Landscape Review Committee
Community Development Center, 231 NE 5th Street
June 11, 2018
12:00 PM

DATE: June 11, 2018
TO: McMinnville Landscape Review Committee
FROM: Chuck Darnell, Associate Planner
SUBJECT: Agenda Item 4A: L 1-18

Revised plans for street trees and landscaping of open space tracts within multiple phases of a subdivision (L 1-18) to be reviewed by the Landscape Review Committee.

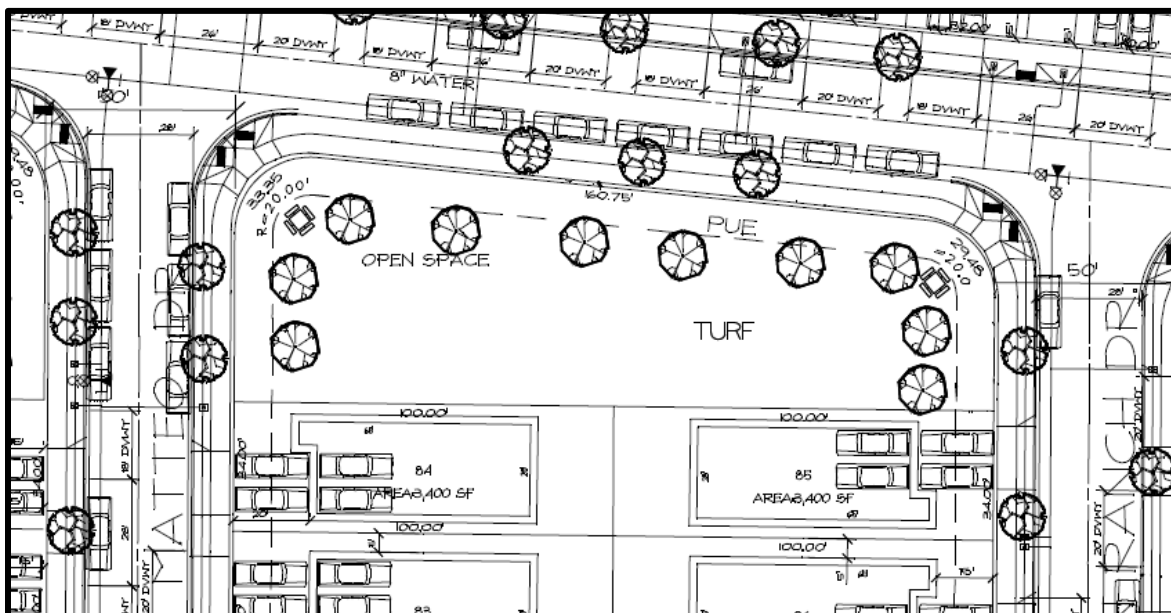
In the detention area in Tract A, the applicant is proposing to add four more Excelsa Western Red Cedar (*Thuja plicata* 'Excelsa') trees along the outer perimeter of the detention area, for a total of 13 trees. The applicant will also install water quality seed mix within the graded detention area. The applicant provided details for the water quality seed mix being proposed, which includes a mixture of Slough Sedge, Small Fruited Bulrush, Dense Sedge, and Creeping Spikerush.

Open Space (Tract C):

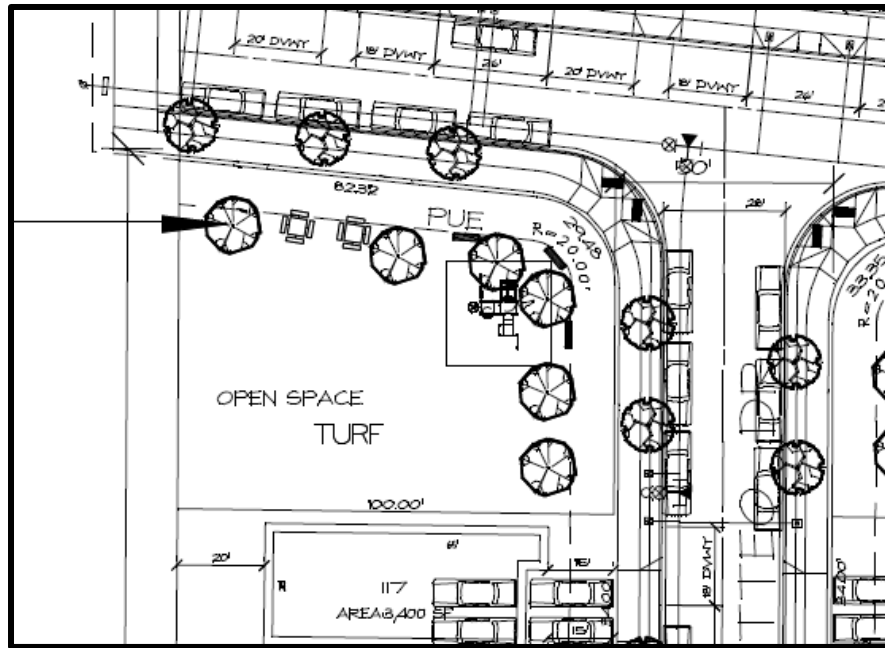
In this open space tract, the applicant is proposing to add one additional Katsura (*Cercidiphyllum japonicum*) tree along the outer perimeter of the open space tract, for a total of 10 trees.

Open Space (Tract D):

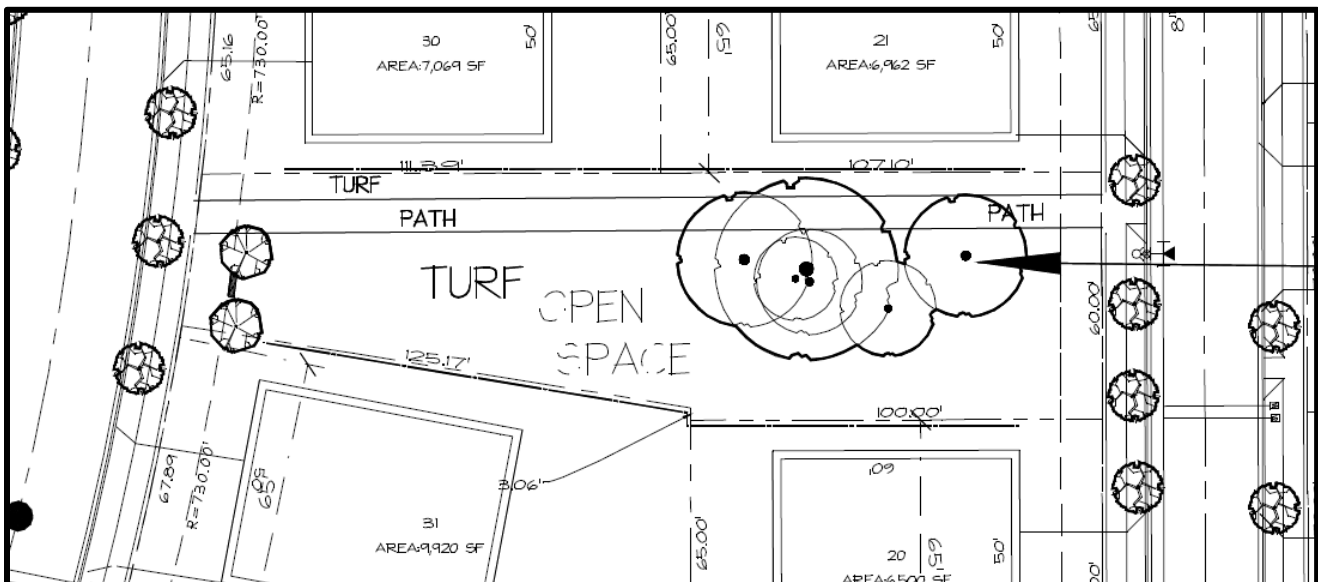
In this open space tract, the applicant is proposing to add 3 additional Katsura (*Cercidiphyllum japonicum*) trees along the outer perimeter of the open space tract, for a total of 6 trees.

Open Space and Pedestrian Accessway (Tract A):

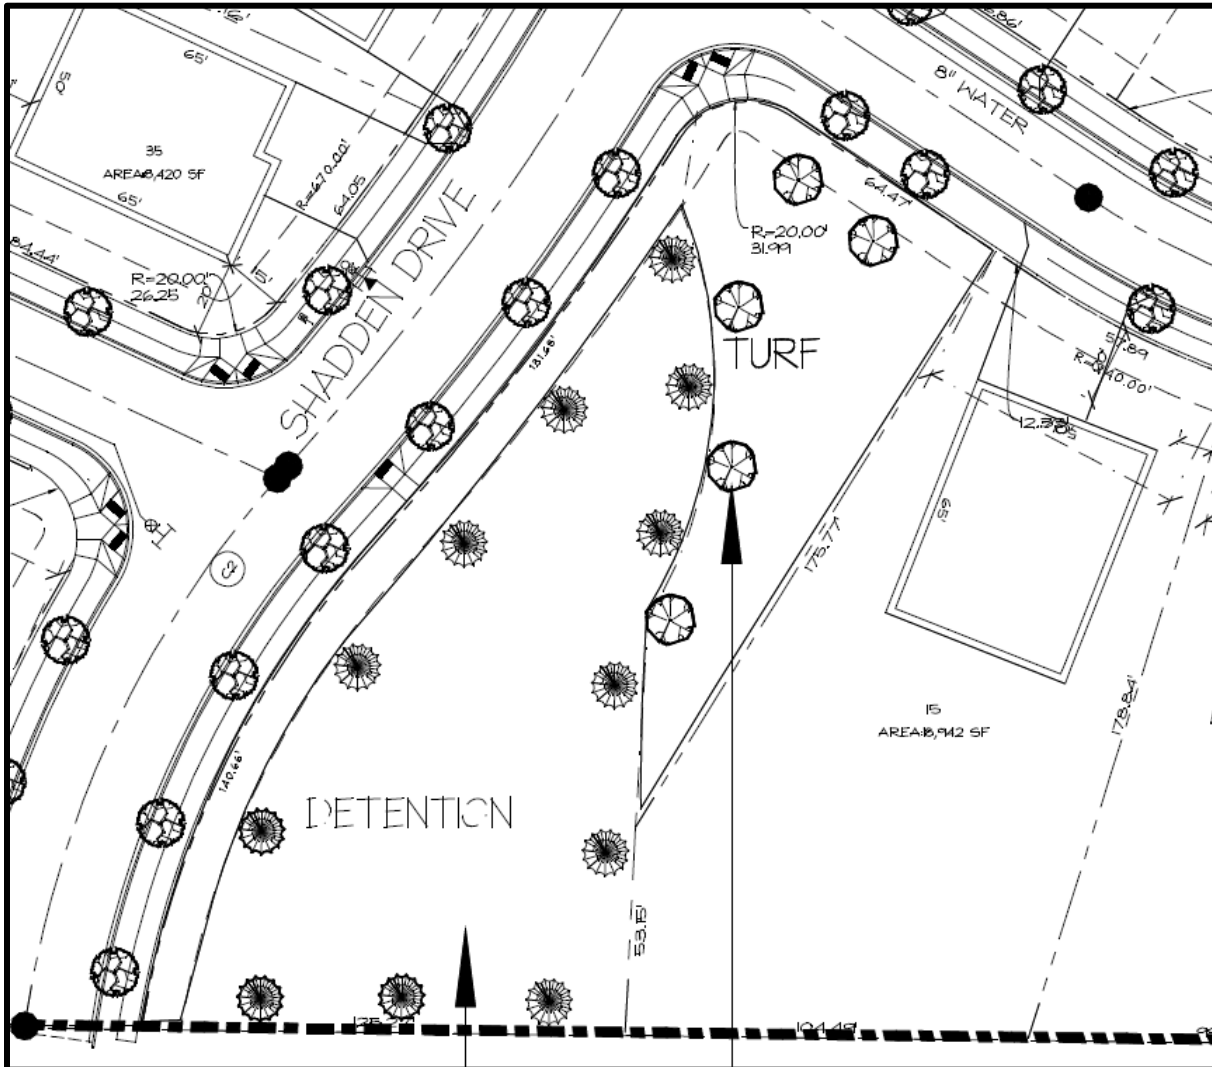
In this open space tract, the applicant is proposing to add 2 additional Katsura (*Cercidiphyllum japonicum*) trees along the western perimeter of the open space tract, where previously they were not showing any trees.

Open Space and Detention Area (Tract B):

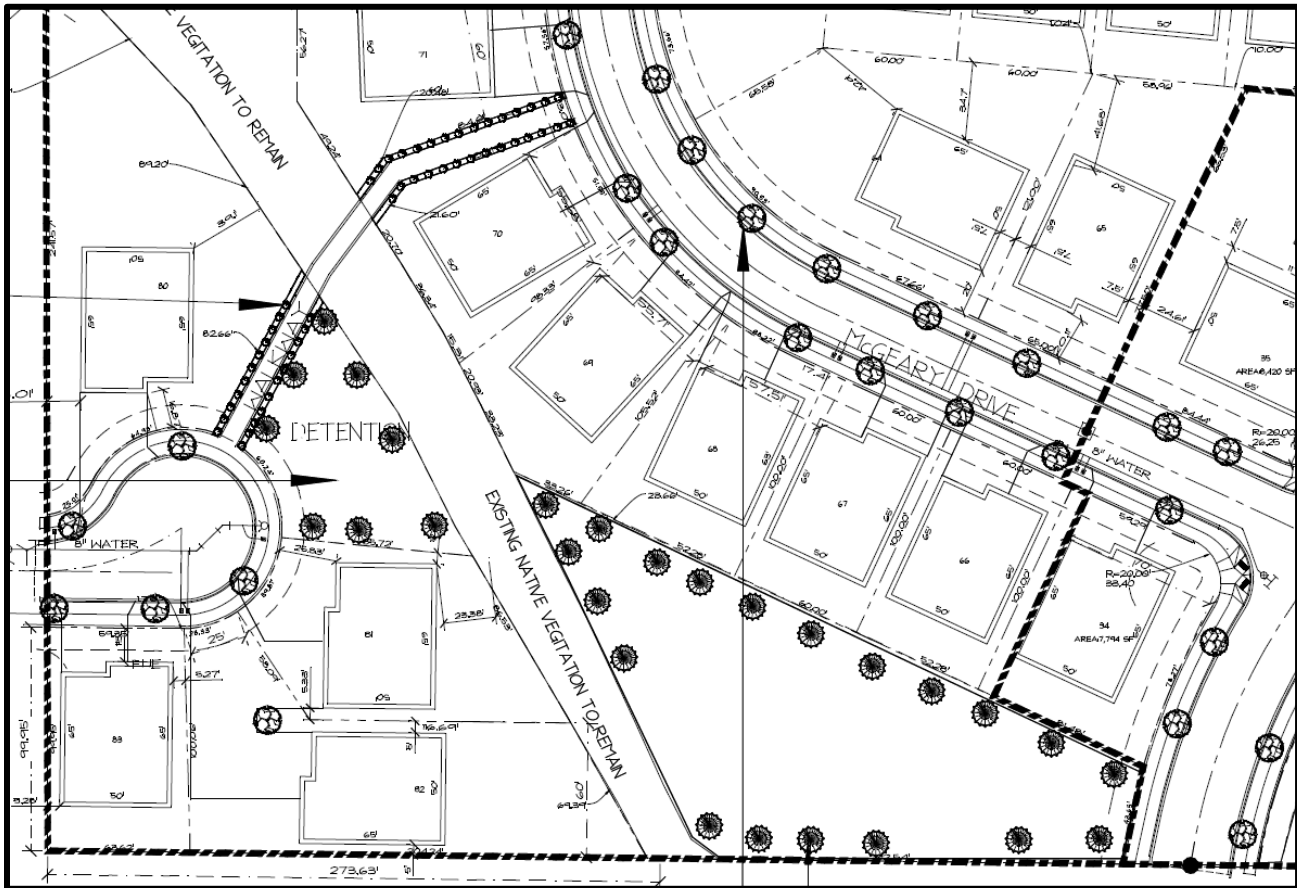
The applicant added one additional Western Red Cedar tree to the perimeter of the detention area, and also added 5 new Katsura trees along the perimeter of the turf area. Previously, they were not showing any trees in the turf area.
